SERVICE BULLETIN

No. 355

Piper Aircraft Corporation

Subject: Fuel Selector Valve Lubrication

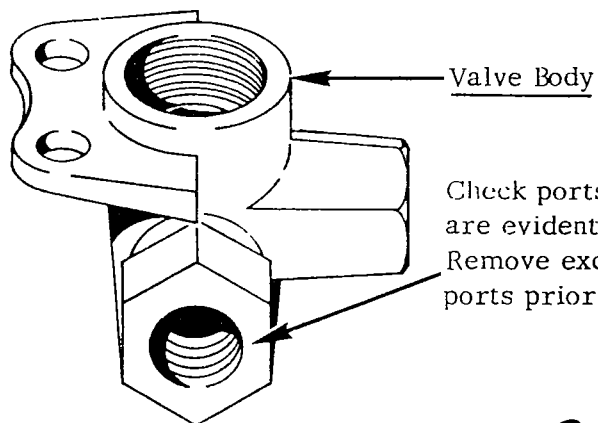
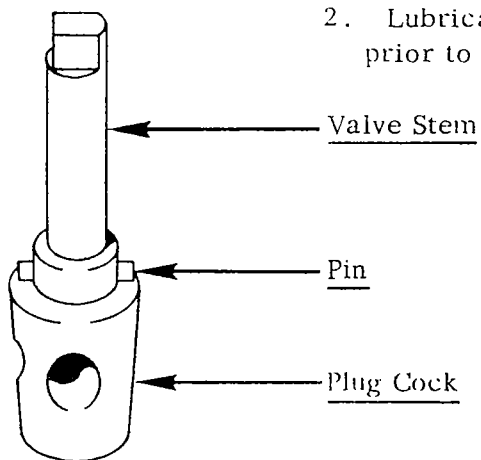
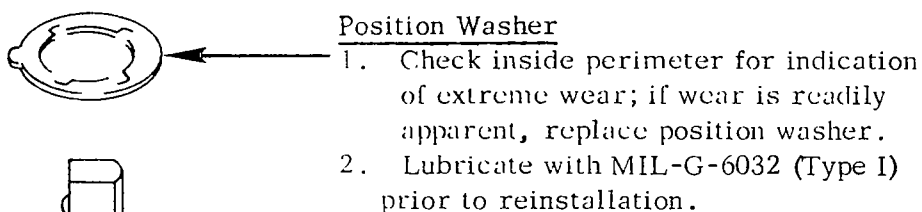
1. With the valve removed from the aircraft, remove the valve cap and interior parts (see attached sketch for an exploded view of valve components).
2. Inspect position washer to ascertain that it will not allow the valve to rotate beyond its stop positions. Also, inspect position washer inner perimeter surface for indications of extreme wear; should this be evident, replace position washer (see Material Required, below).

Check ports for cracks; if cracks are evident, replace valve. Remove excess grease from ports prior to reinstallation.

3. Check condition of plug cock and valve body for scored surfaces. The surfaces, if not badly scored, may be conditioned by lapping with a fine grinding compound. Clean away all compound after lapping. If plug cock will not seat properly or if scoring remains evident, replace valve.

4. Check condition of valve stem in the area where the "O" ring seats. Should the stem be worn or damaged so that the "O" ring will not seal, replace valve.

5. With a 10X magnifying glass, inspect valve ports for cracks; if cracks are visible, replace valve.
6. Clean valve of all foreign matter, lubricate plug cock with a light film of MIL-G-6032 (Type I) grease, turn the plug several times in its seat and wipe off any excess, especially in the valve ports. Also, lubricate position washer with a light film of MIL-G-6032 (Type I) grease. Reassemble valve with a new "O" ring, Piper part number 752 822.
